RE: Bernheim Middle School - Change Order 31 – Miscellaneous Exterior Work **DC**

PROJECT: *(Name and address)*
 Bernheim Middle School Renovation
 700 Audubon Drive, Shepherdsville, KY
 40165

CHANGE ORDER INFORMATION:
 Change Order Number: 031
 Date: November 25, 2024

Change Order Request 45 - PCO #148 - Added Downspout at Science Patio

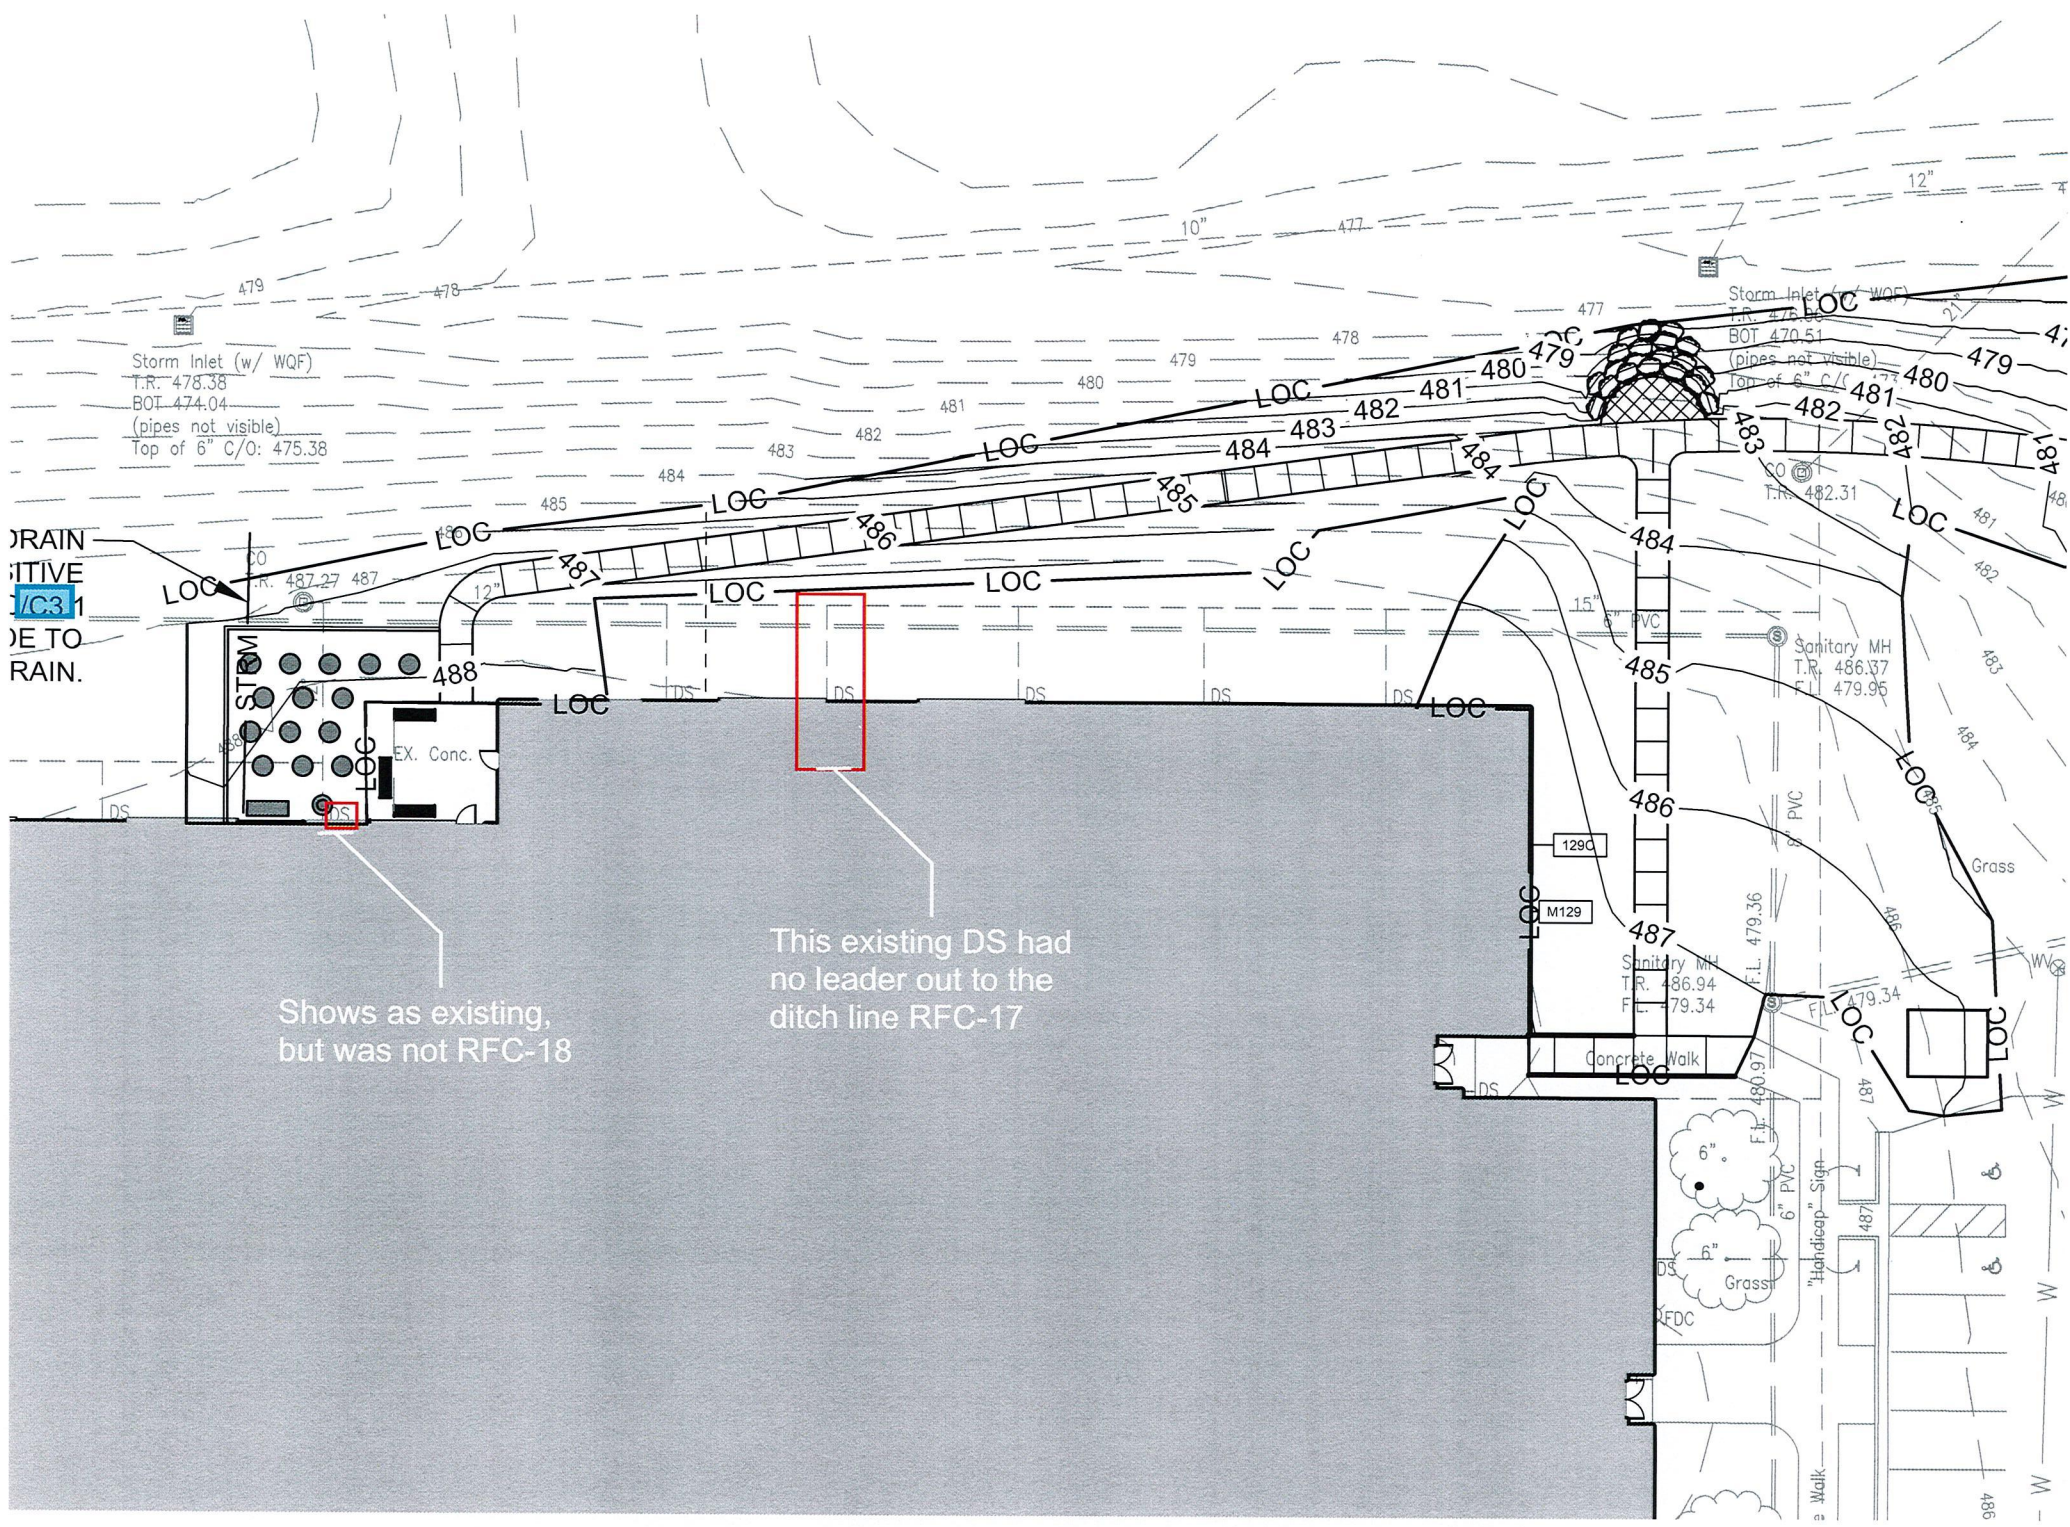
Shows as existing,
 but was not RFC-18

This existing DS had
 no leader out to the
 ditch line RFC-17

Additional Roof Drain to Patio Section

Additional Downspout & Moving Existing Downspout
